Communication and Electronics Service Test Division

AFSAM 7

PROJECT CE 1552

~~SECRET~~APPENDIX D - COORDINATIONREPORT OF TEST - PROJECT NO CE 1552

VEHICULAR MOUNTINGS FOR AFSAM 7

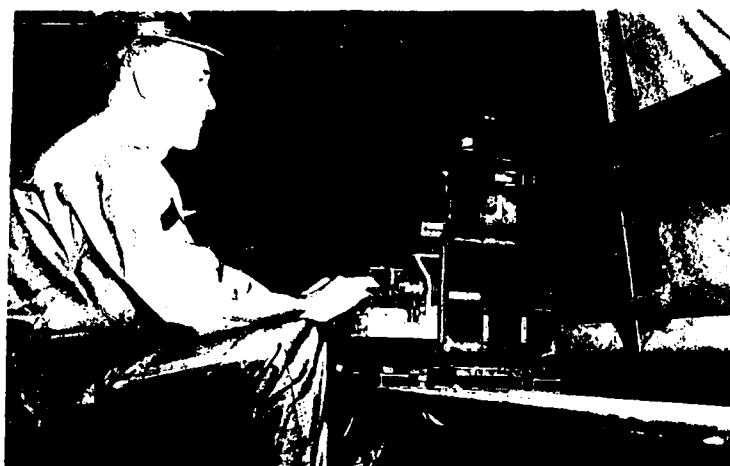
LEFT: CASE, SHOWING CHANNEL MEMBER PLATE ADDED LOCALLY TO ENABLE USE OF STANDARD TYPE MOUNTING MT-791/U

RIGHT: CASE WITH FITTINGS, AND SPECIAL MOUNTING BASE SUPPLIED WITH AFSAM 7
